AEROSPACE STANDARD AMENDMENT

SAE AS39029/31-A1

Issued 2005-04

Contacts, Electrical Connector, Pin, Crimp Removable
(for MIL-C-26482 Series 1, MIL-C-26500 and MIL-C-26518 Connectors)

1. Present requirement: Figure 1 on sheet 2

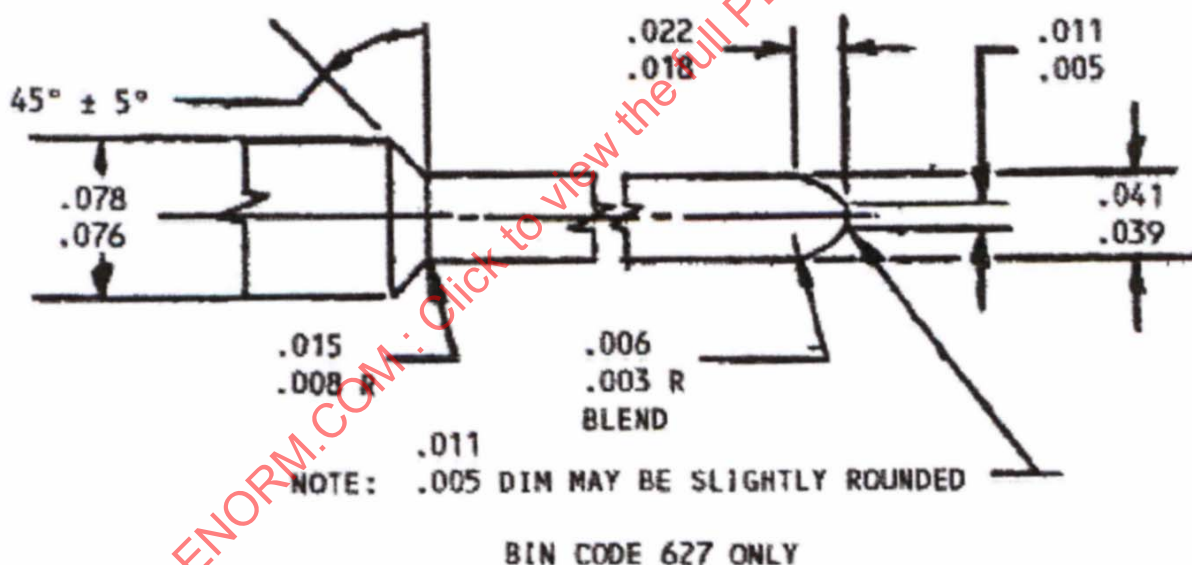
Change requirement: Figure 1 on sheet 2, add figure below

Rationale for change: Add MIL-C-39029/31 amendment 1 to Word-For-Word
AS39029/31
